**APPLICATION 2017-663 STAFF REPORT  
BAINBRIDGE APARTMENTS**

Pre Public Hearing Staff Analysis • September 2017

**From:** Chief Rob Hunter  
**To:** Jay Camp, Town Planner  
**Date:** September 8, 2017  
**Subject:** Review of Proposed Site Plan

Ref: **Bainbridge Rezoning proposal**

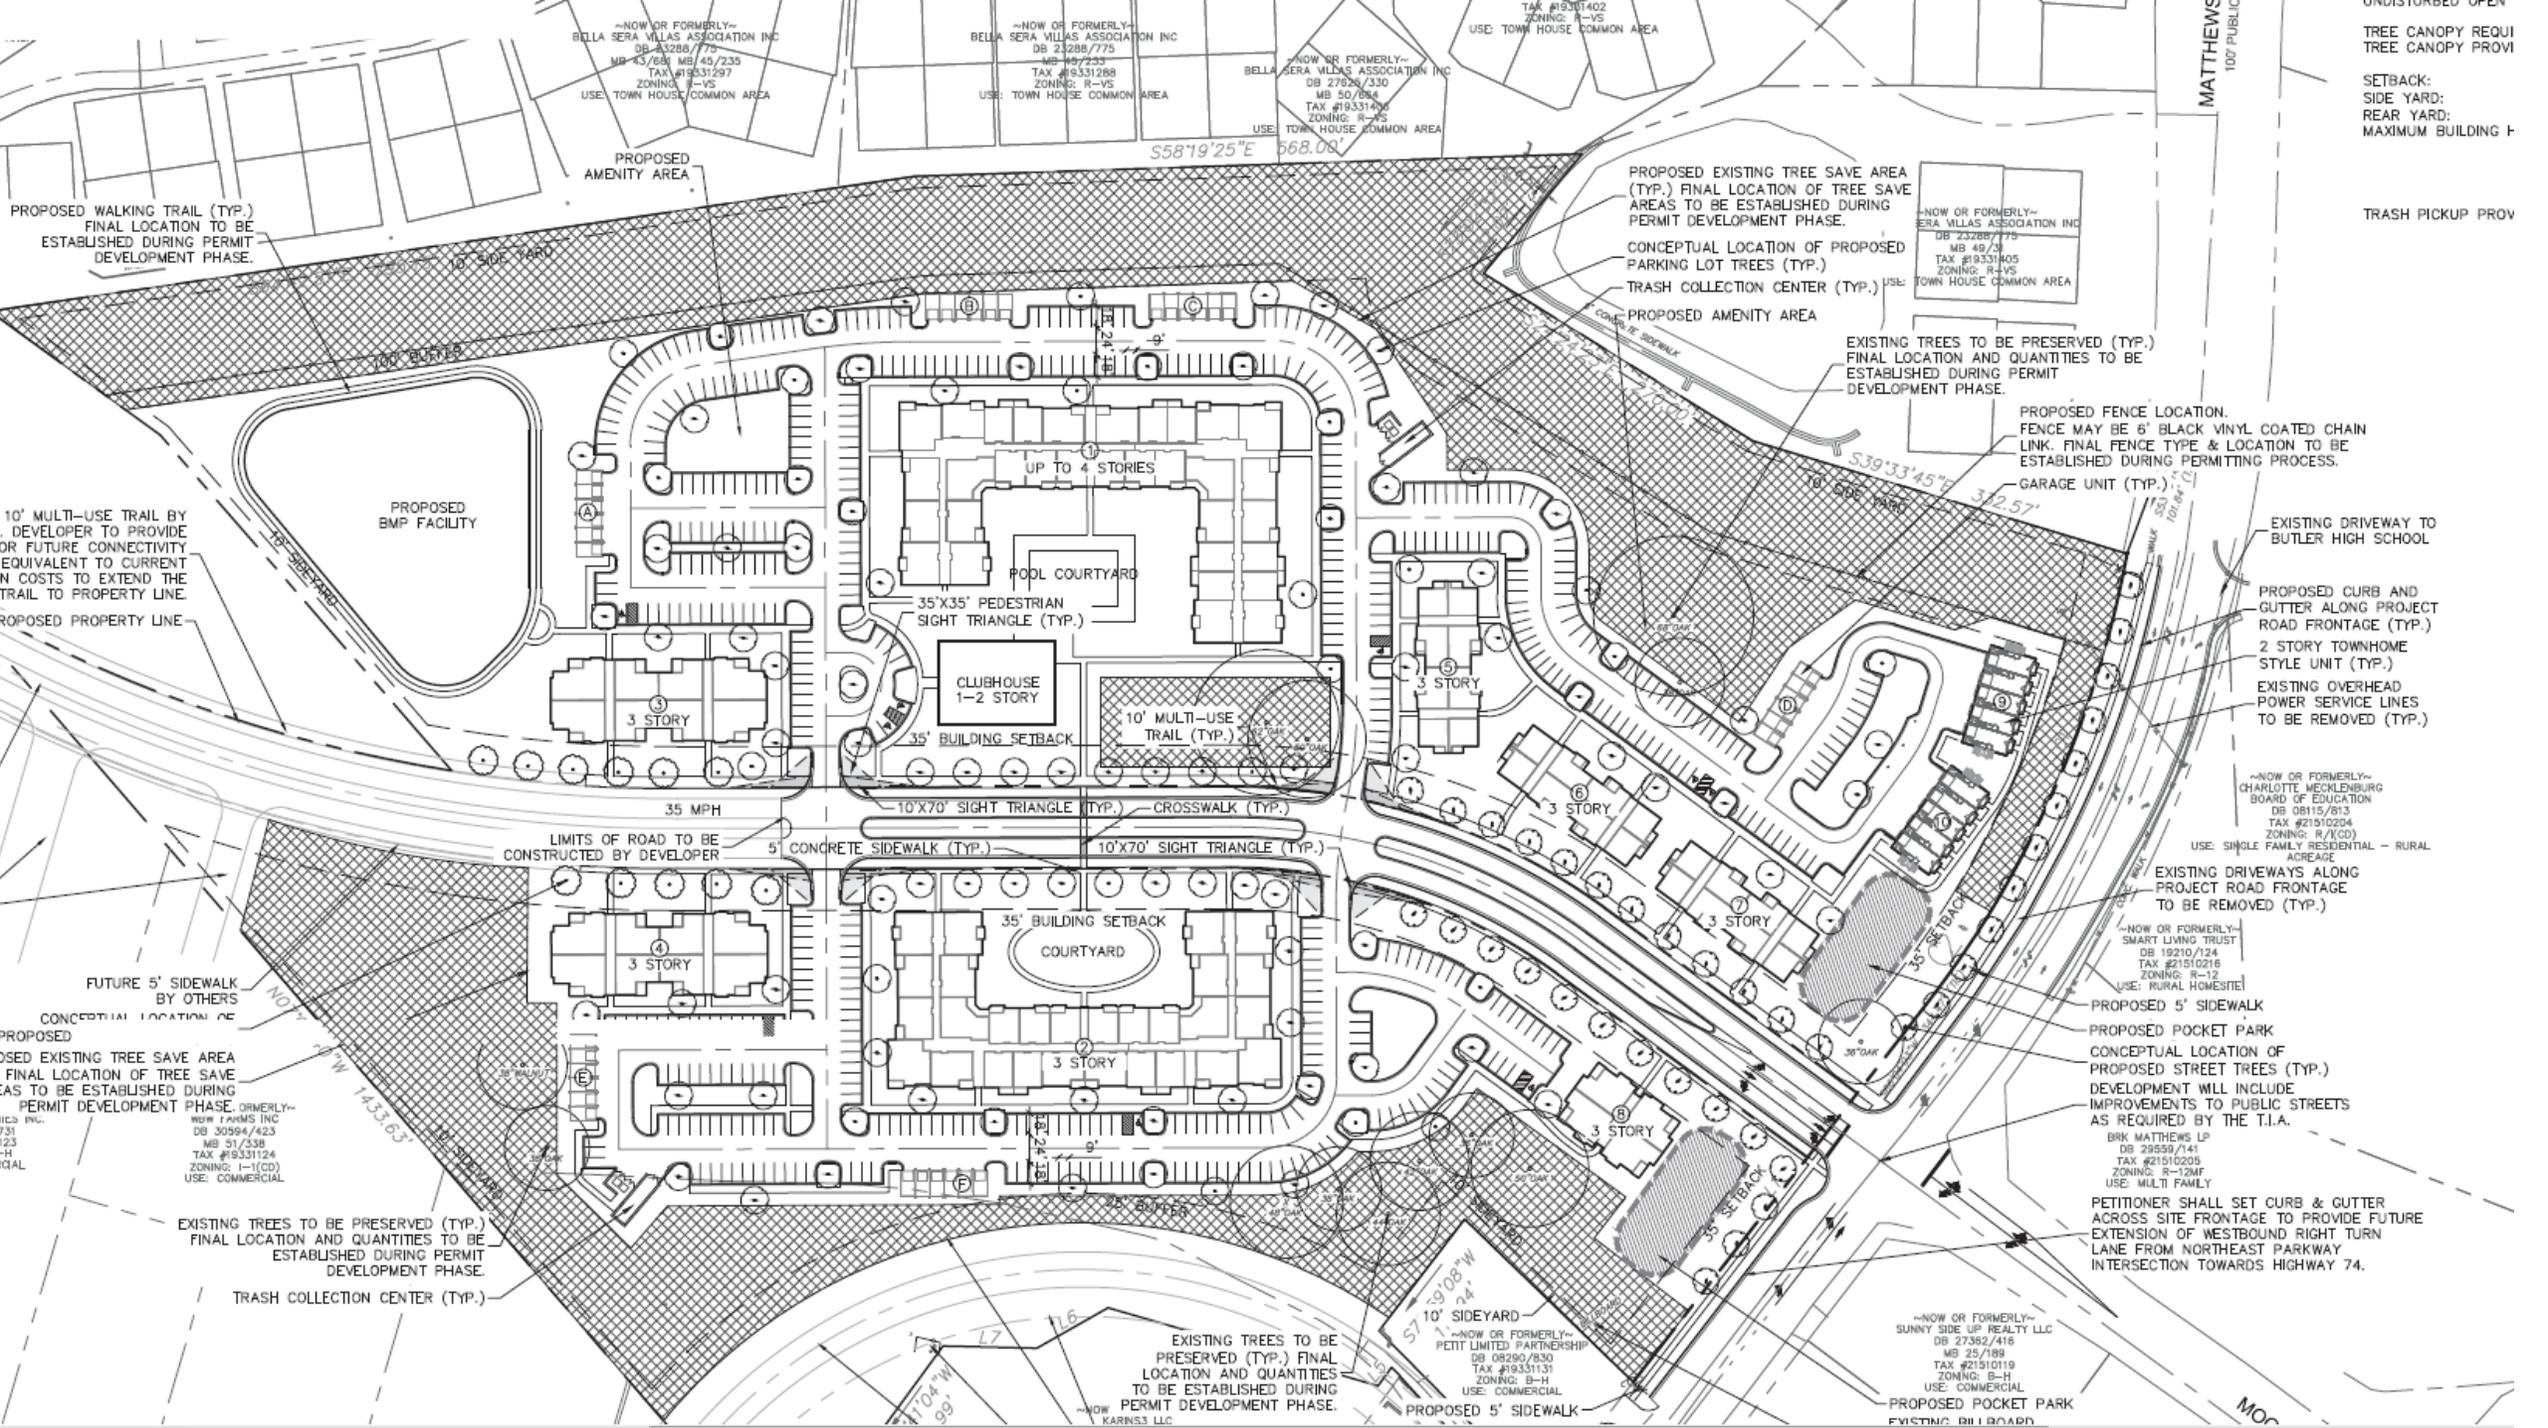
1. Building height should be shown to confirm that the proposed 4-story buildings meet the 45' maximum building height.
2. Current site plan does not show an appropriate treatment for the Northeast/Matthews-Mint Hill intersection.
3. More detail required for proposed pocket parks at Northeast/Matthews-Mint Hill.
4. The current site plan does not provide adequate street connections as required in the UDO. To meet code, the connection to Highway 51 must be installed. Only 100 units can be constructed with a single access to Matthews-Mint Hill.
5. No elevations given for detached garage structures.
6. Confirmation needed that NCDOT will definitely allow midblock pedestrian crossing to connect the two portions of the development.

**Comments:** While I do not have concerns with multi-family development in that area, I would offer the following concerns / considerations for staff and the Board's considerations:

- Safety: With residential development proposed on both sides of Northeast Pkwy, and development amenities only on one, pedestrian crossing, especially children & teens, would be anticipated

- Safety: If approved, would recommend the portion of Northeast Pkwy they develop be extended to the end of the building footprint area to allow for fire truck access to sides/rear of those buildings

- Safety: They state are prepared to install street lighting at corner of Matthews Mint Hill; I would recommend that be required as school bus stop will likely be on Matthews Mint Hill Rd

- Safety: To ensure prompt emergency responses, I would recommend that, should the internal streets be independently named (not all use Northeast Pkwy addresses), that the street names are different on the opposing sides of Northeast Pkwy

- Safety: I do not see indicated the proposed location of postal boxes for residents; would recommend they be located in a high-visibility, well-lit locations

- Traffic: Will they be required to present a ‘future’ traffic study for Northeast Pkwy to assure two single lanes, with no area for expansion, will be sufficient to carry the road’s traffic volume once Northeast Pkwy is opened between NC51 and Matthews Mint Hill Road?

- Traffic: There appear to be no provisions , with proposed concrete media island, for dedicated left-turn lanes into their property; when Northeast Pkwy opens, this will create traffic disruptions and potential rear-end

- Traffic: Will the “Improvements to Public Streets as required by the T.I.A.” include repairs to the degraded curb-lane area on the opposite side of Matthews Mint Hill as it approaches Moore Road? As proposed, that currently widens but not marked area would become the marked thru lane and its condition is very poor

- Traffic: Their proposal to “Set curb and gutter across site frontage to provide for future extension of the westbound right-turn lane from Northeast Pkwy towards US74” would result in an abrupt termination point at the adjoining property line, which, depending upon how marked & signed, could result in crashes. Would suggest either completion of the right-turn lane beyond their property line or construction in such a manner as to eliminate the potential for crashes.

An 'Approved' fire department access road, 20 feet wide needs to be provided which extends Northeast Parkway westward to the end of buildings 3 and 4.

The proposed design of Northeast Parkway as shown in cross section A on page RZ3.00 meets the requirements of the fire code for a fire department access road. However, a divided roadway using the proposed fire apparatus rated grass pave material will not allow for the installation of trees or any other plantings in the median at any time in the future.

No Parking is allowed at the end of parking isles or bulbs. Given 350 units, the number of proposed parking spaces, 594, seems low. Fire Lane designation, marking, and signage may be required.

Pedestrian crossing in center of project needs to have improvements (signs, lights, raised pavement, etc) that indicate a mid-block crossing.

Fire hydrants should be provided along Northeast Parkway as well as internal to the development. Fire hydrants and building fire department sprinkler connection locations must be coordinated with fire department.

Each building needs to have a separate street address. Addressing Townhomes may be problematic.

## Extension of Northeast Parkway

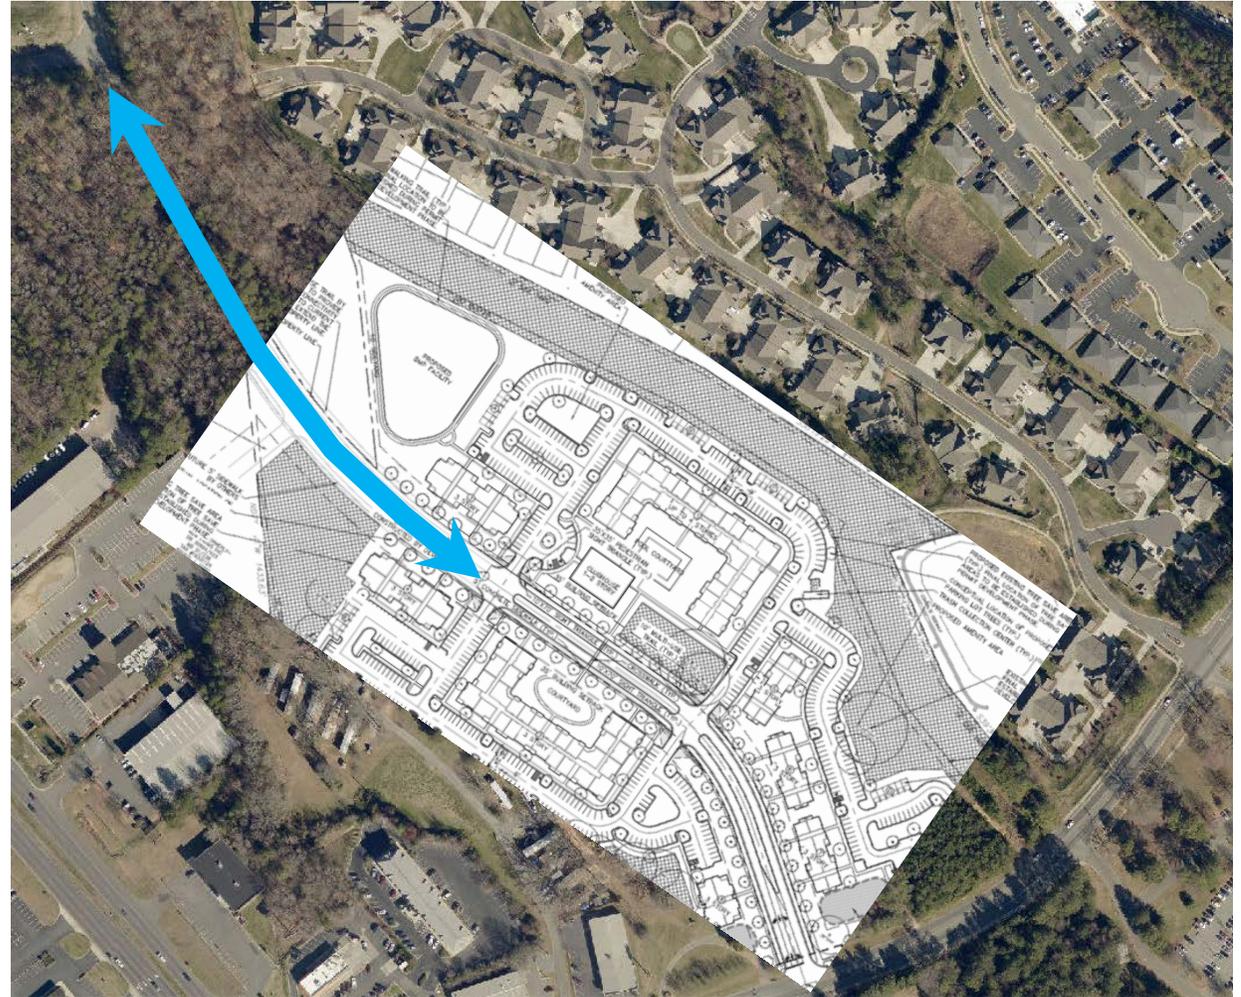
The applicant has worked with the NCDOT and Town staff for many months to determine how best to complete Northeast Parkway. There is additional right of way required to connect to the existing terminus of the roadway at Matthews Corners. The applicant is seeking to build at a minimum a portion of the roadway through the development and have NCDOT reimburse the cost associated with the road but has yet to secure an agreement. As currently shown, there would be about a 1,200' gap keeping Northeast Parkway from connecting through to 51.

Also of concern is the intersection treatment at Matthews-Mint Hill and whether it should be a signal or roundabout. Studies related to the US74 project are anticipated to provide guidance for the intersection but are not yet complete. The design as currently shown with only turn lane improvements is unacceptable.
